**Concept plan for residential development at
the Crowle Home / Achieve Australia site,
74-76 Belmore Street, Ryde**

MP10_0110 MOD3

Secretary's
Environmental Assessment Report
Section 75W of the
Environmental Planning and Assessment Act 1979

May 2014

Figure 7: Proposed staging plan (Base source: proponent's Response to Submissions)

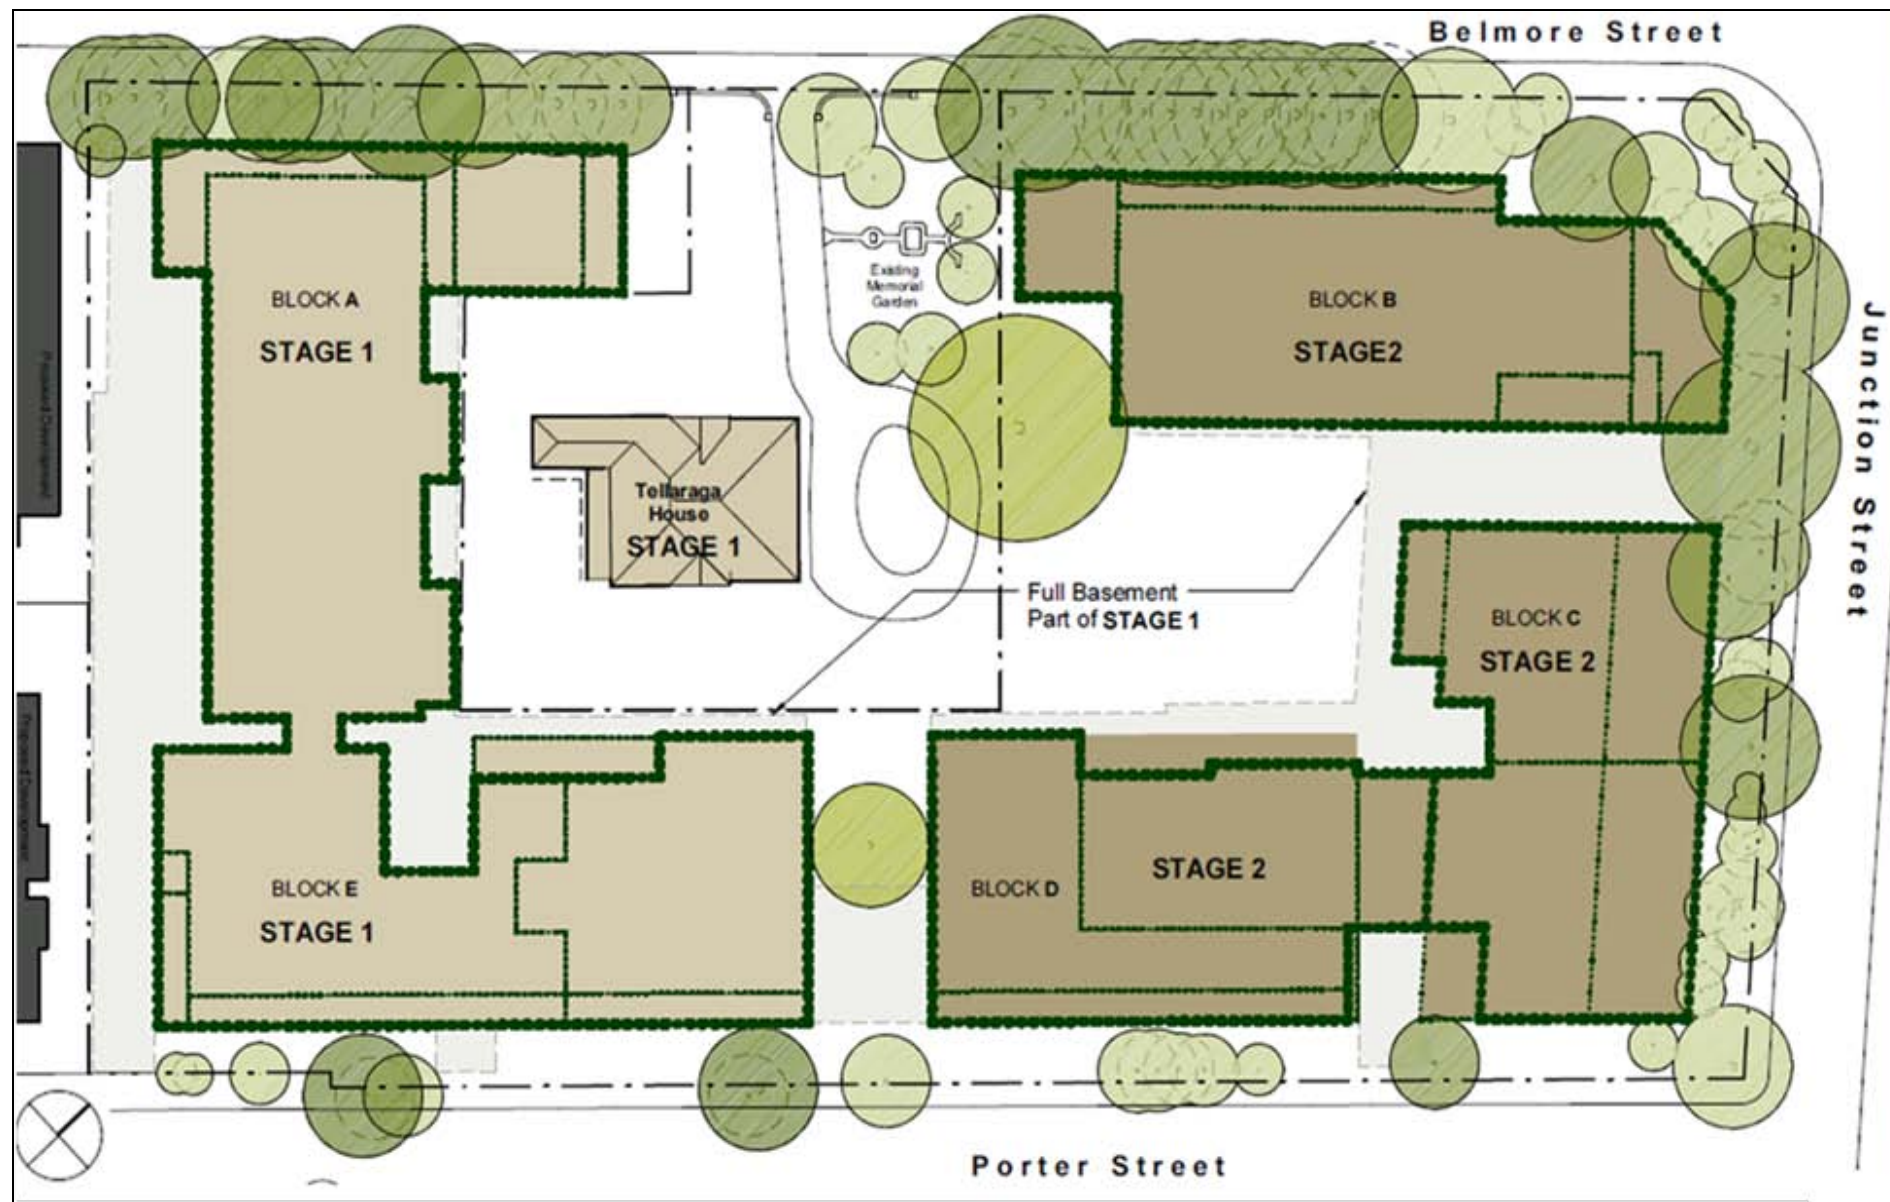
- a reduction of development stages to two stages, with Stage 1 comprising Blocks A, E, Tellaraga House and the site wide basement and Stage 2 comprising the remaining Blocks: B, C and D (refer to **Figure 7**); and
- an amendment to the wording of condition C15 to require the restoration of Tellaraga House no later than the issue of the first occupation certificate for the apartments within the development.

Council has also raised concern about the proposed alteration of the timing of the restoration until first occupation as excavation of lands adjacent to Tellaraga House and demolition of the 1970s building (attached to Tellaraga House) may occur prior to restoration. Council recommended that the condition remain in its current form. Council raised no objection to the proposed amendment of the staging of the development.

It is the department's view that the amendment of the timing of the restoration of Tellaraga House to prior to occupation of the development is acceptable subject to the following additional amendments to condition C15:

- the CMP shall be submitted with the first development application to Council;
- the CMP shall include details of the protection of Tellaraga House during excavation, demolition and construction stages; and
- no demolition or excavation works within 20 metres of Tellaraga House shall commence prior to the submission of the CMP.

Figure 8: Approved (left) and proposed (right) extent and separation of Blocks A and E (Base source: original EA MP10_0110 and proponent's Response to Submissions)

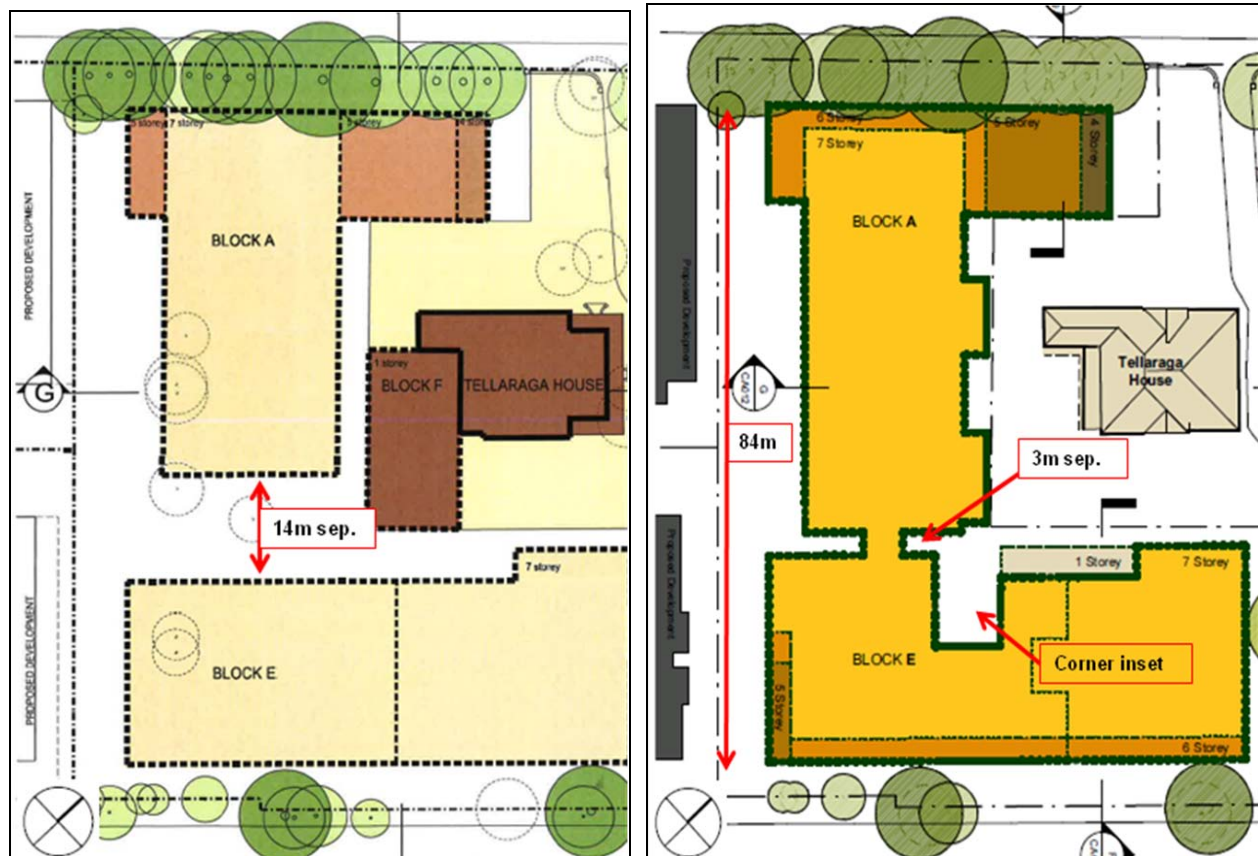
As approved, Blocks A and E are provided with a separation distance of 14 metres. The proposal seeks an expansion of the building envelopes of Blocks A and E and consequential reduction of the separation between the Blocks to 3 metres. A 4 metre wide connection is proposed between Blocks A and E and a corner inset is proposed to Block E (refer to **Figures 6 and 8**).

Council has objected to the enlargement of the building envelopes, reduction of the separation distance between Blocks A and E and creation of the corner inset. Council has stated that the amended building envelopes would result in the provision of apartments with poor amenity (in terms of outlook, solar access and privacy) and insufficient information has been provided to determine whether the apartments within Blocks A and E would achieve appropriate solar access.

Overall and notwithstanding the enlargement of building envelopes and reduction of separation distance between Blocks A and E, the department considers that the proposal would be capable of providing apartments that would achieve acceptable standards of amenity in terms of outlook, privacy and solar access. Furthermore, the department notes the additional benefit that the proposal would be capable of delivering an increased number of dual aspect apartments.

Figure 9 : The indicative (left) and proposed (right) apartment layouts of the southern portions of Blocks A and E (Base source: original EA MP10_0110 and proponent's Response to Submissions)

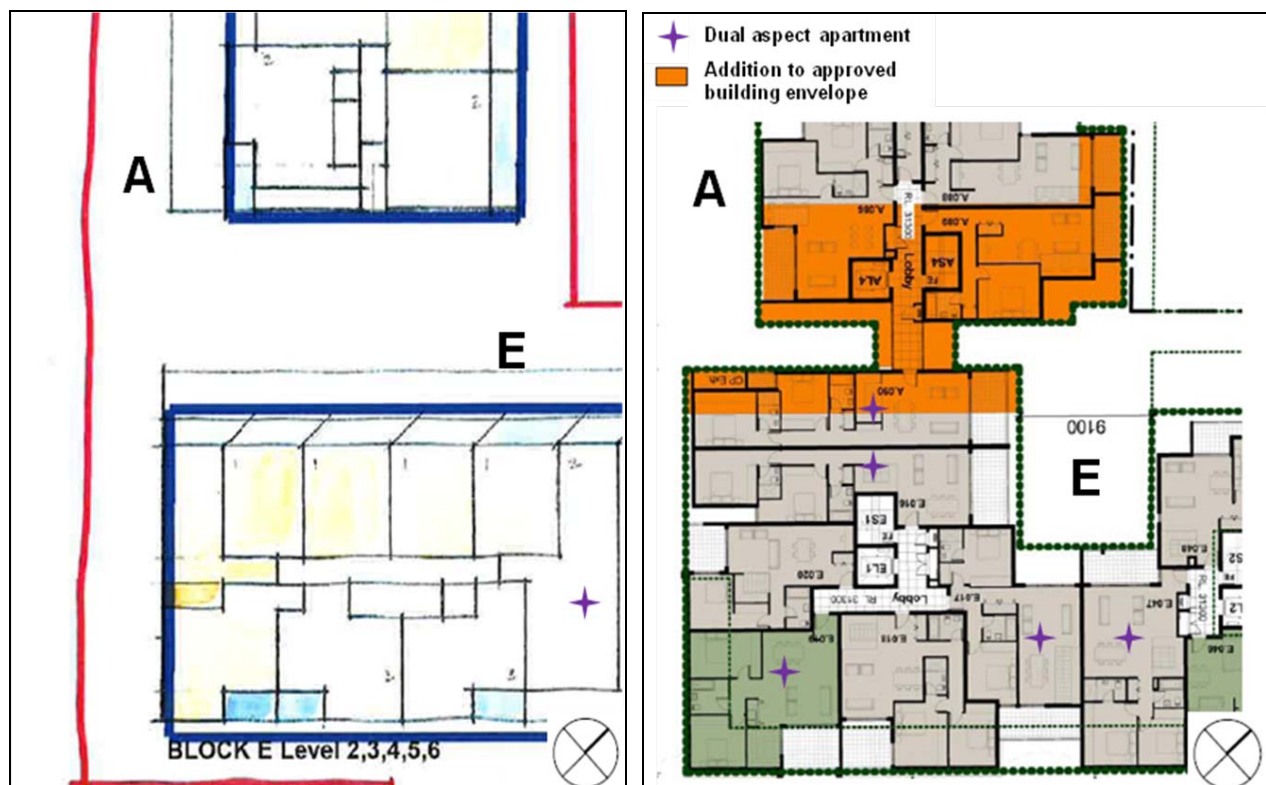
The department notes that the original indicative apartment layout (refer to **Figure 9**) showed multiple single aspect apartments within Block E, which would have an outlook onto the blank flank wall of Block A (refer to **Figure 9**). The department notes that:

- the revised layout indicates that it would be possible for an additional four dual aspect apartments to be provided per floor;
- all the apartments which have an aspect facing the corner inset are dual aspect apartments and therefore the aspect into the corner inset would not represent their only outlook; and
- direct and oblique views into the central courtyard would be possible from apartments within the corner inset.

The department therefore considers that the proposal is capable of providing for apartments with an acceptable standard of outlook in this location.

Figure 10 : Building envelope elevations (highlighted in blue) with a southerly aspect (Base source: proponent's Response to Submissions)

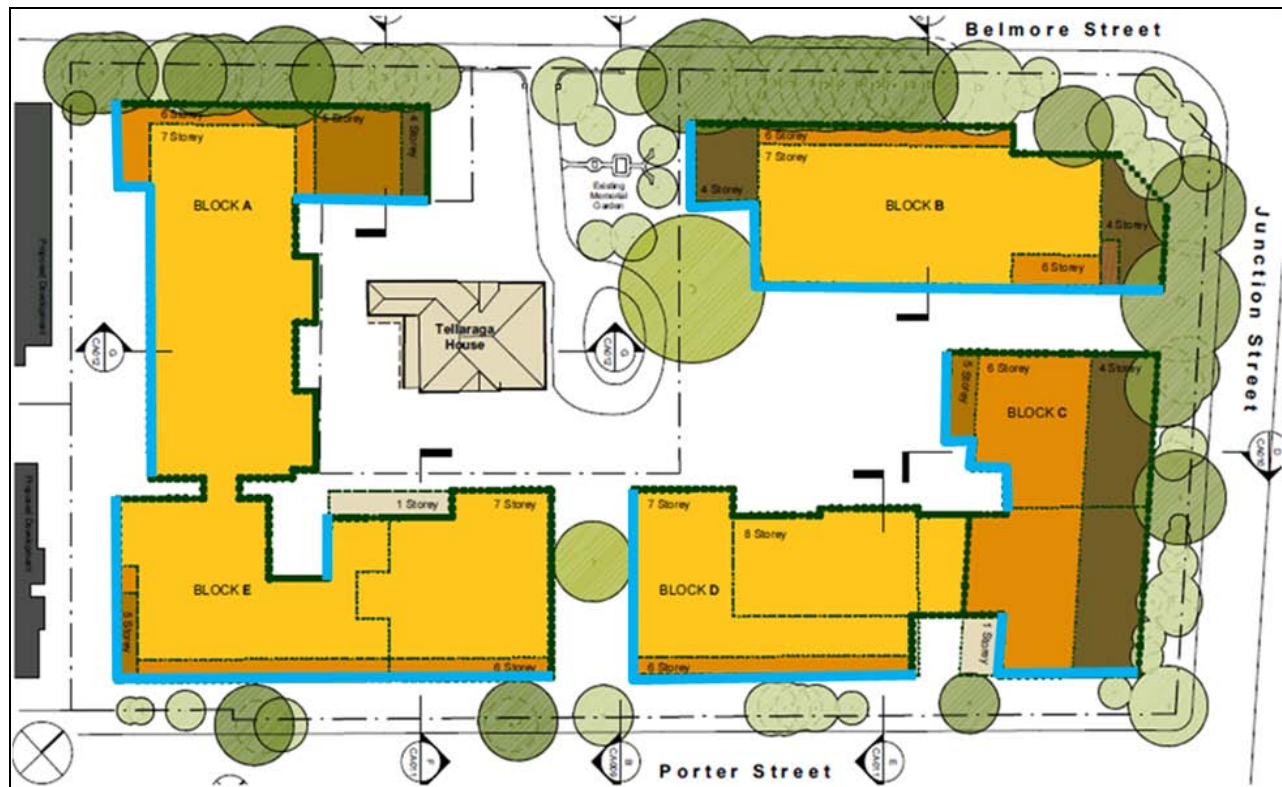
The proponent states that further detailed design investigations have shown that apartments site-wide can achieve the solar access requirements. However, due to the orientation of buildings and the extent of south facing building envelopes, building by building compliance is too onerous. Furthermore, the proponent notes that many of the building envelope changes proposed as part of this modification request application are to improve solar access for future residents in an attempt to comply with condition C2(a).

Council is of the opinion that the existing approved building envelopes should be able capable of achieving compliance with the existing solar access requirement.

The department notes the proponent's proposed amendment to condition C2(a) would maintain the same percentage of apartments required to achieve the intended solar access outcome. The amendment simply seeks flexibility in the location of those compliant apartments within the development. Given the orientation of the approved/proposed building envelopes and as the total number/percentage of compliant apartments will remain the same the department considers it reasonable to allow flexibility as sought, particularly as this would assist the development to achieve the required solar access outcome. It is recommended that Condition C2(a) be reworded accordingly.

Figure 11 : The relationship between the proposed building envelopes, 2-4 Porter Street and the through site pedestrian link (Base source: proponent's Response to Submissions)

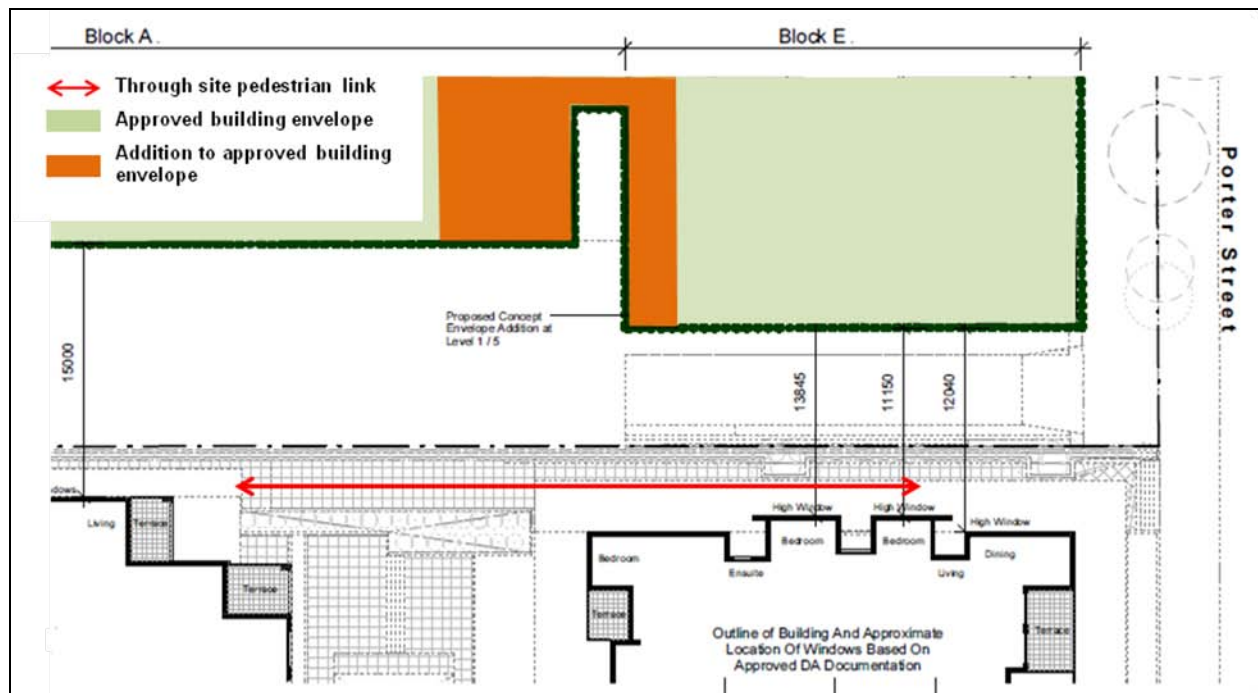
The proposed reduction of the separation distance between Blocks A and E would alter the relationship of the proposed development with the neighbouring buildings at 2-4 Porter Street and the publicly accessible through site pedestrian link running along the north eastern boundary of 2-4 Porter Street. The relationship between the proposed building envelopes and 2-4 Porter Street is shown at **Figure 11**.

The department notes that the apartments located within the 2-4 Porter Street building, south of the proposed expanded building envelopes (shown in orange in **Figure 11**), are dual aspect. Furthermore, only high level bedroom, secondary living room and bathroom windows exist along the north east elevation (levels 1 to 5) of the building. At level 6 regular windows exist facing north east, however, these windows are set back and located over 18 metres away.

The department considers that given the design of the 2-4 Porter Street building and the dual aspect nature of the apartments, the bulk and scale of future buildings would not be readily seen/perceived from neighbouring windows within 2-4 Porter Street. Consequently, the department does not consider that the proposed amendments to the separation distances of Blocks A and E would have an adverse impact the neighbouring property in terms of presenting unacceptable visual bulk. The department notes that the submitted solar analysis indicates that the proposed changes would only have a marginal impact on the amount of sunlight reaching 2-4 Porter Street (approximately 2 hours of sunlight at mid winter between 9am and 3pm would still

be afforded to that property) and therefore considers that the proposed alteration would not have an unacceptable impact on the neighbouring property.

Figure 12: Proposed south western setback to Block E (Base source: proponent's Response to Submissions)

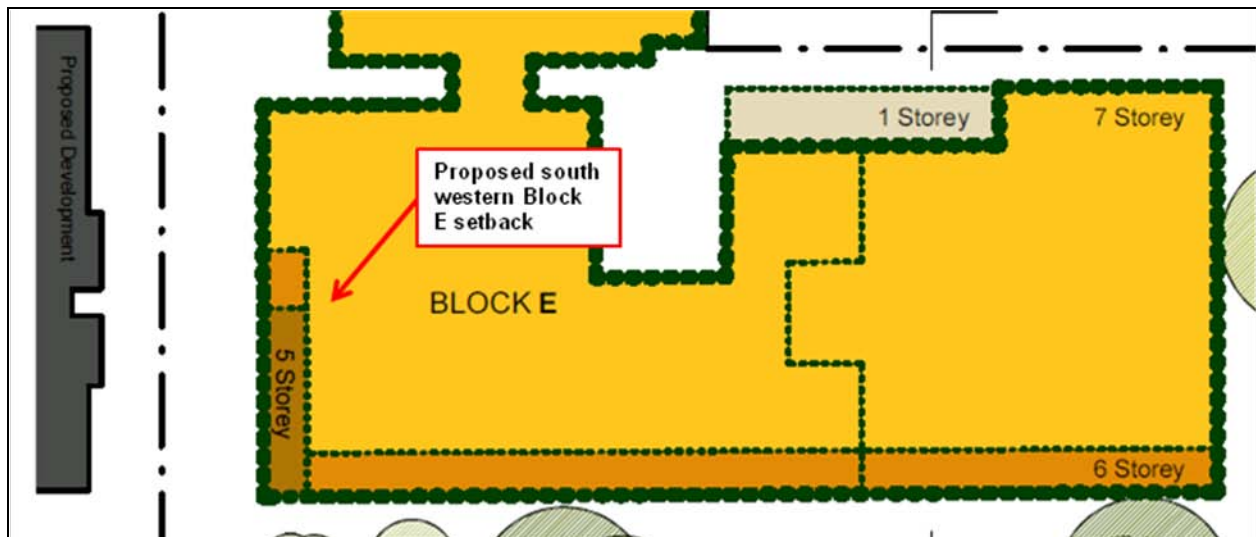
Condition C1(b) of the concept approval requires that the upper two storeys at the south western elevation of Block E be set back a minimum of 5 metres from the façade of the building. The department notes that the reason for this setback was to establish a sympathetic visual bulk relationship between the adjacent 2-4 Porter Street development and proposed Block E. The proposal seeks to provide an alternative south western setback to Block E (refer to **Figure 12**) and delete condition C1(b). The setback would comprise:

Council has raised concern that the amendment and part removal of the setback would adversely add to the visual bulk of the building when viewed from public domain.

In its assessment of the original concept plan the department considered that a 5 metre setback in this location would provide an appropriate relationship between the existing and proposed buildings and that such a setback would allow for a suitable transition between the differing heights of the two buildings. The department notes that the proposed setback arrangement is stepped and reduces moving north west away from Porter Street to no setback at all. The department considers that the proposed additional bulk would be readily visible from the neighbouring publicly accessible through site link and also from Porter Street and that the additional bulk would result the proposed building having an unsympathetic and visually dominating impact on 2-4 Porter Street (refer to **Figure 13**). The department therefore considers it appropriate that condition C1(b) and the 2 storey, 5 metre setback (as currently approved) be retained.

Figure 14: The approved (left) and proposed (right) setback to upper floors of Block A as viewed from Belmore Street (Source: proponent's Response to Submissions)

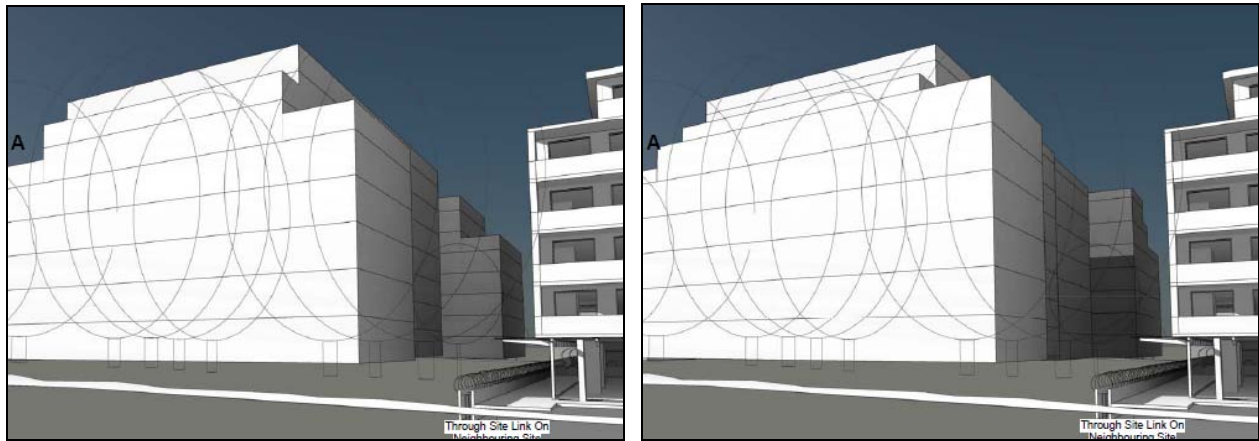
The currently approved building envelope for Block A, at the Belmore Street elevation, provides for a 7 storey building, which steps down to 5 storeys on either side. Further to the north east the building further steps down to 4 storeys. The proposal seeks to amend the building envelope to include a 3 metre setback to the 7th storey fronting Belmore Street and increasing the height of the 5 storey element either side to 6 storeys. Council has objected to the additional visual bulk caused by the increase from 5 to 6 storey on the south western side Block A (refer to **Figure 14**).

The department considers that the increase to 6 storeys on the south western side of Block A is unacceptable for the same reasons as those given for the south west elevation of Block E (i.e. visual impact and dominance). A condition is recommended which reinstates the setback as approved in this location. The department has no objection to the increase to 6 storeys on the north eastern side of the 7 storey element as this would not result in any adverse visual bulk issues.

Figure 15: The visibility of the northern lift overrun of Block B (Base source: proponent's Response to Submissions)

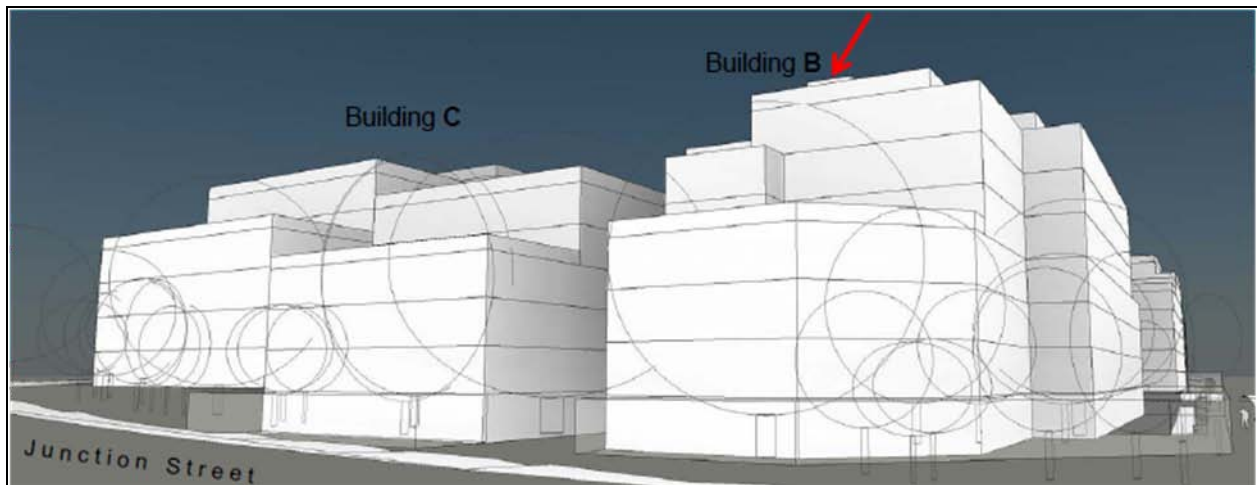
Council has questioned why the additional lift overrun allowance is necessary given that an additional 2 metre allowance was factored into the top floors of the Concept Approval. Council stated that any overrun should not be visible from the street.

The proponent has stated that it has been necessary to increase the floor to floor heights from 3000mm to 3100mm to allow for structural transfer as a result of building setbacks and this has pushed up the building by an additional 700mm. Furthermore, the proponent intends to use machine room-less lifts and these lift designs require lift overrun height of 4.15 metres from finished floor level of the top floor. Although the increase in building height can be accommodated within the extent of the approved building envelopes, the lift overruns are likely to project above the approved building envelopes. The proponent has provided a massing study that takes account of likely lift overrun locations and demonstrates, with the exception of the likely northern lift overrun of Block B that lift overruns would not be visible from the street (refer to **Figure 15**).

The department notes that the 700mm lift overrun allowance represents the maximum height of lift overruns and the proponent's massing study indicates that the northern lift overrun for Block B would be marginally visible from Junction Street (if that lift overrun were to be built to the full 700mm height). The department considers, if the lift overrun were built to the maximum height that the visual impact of the overrun would be negligible. The department also notes that no other lift overrun is likely to be visible from surrounding streets. The department therefore recommends that condition A6 be amended to increase the lift overrun allowance to 700mm and to apply the allowance to all Blocks within the development.
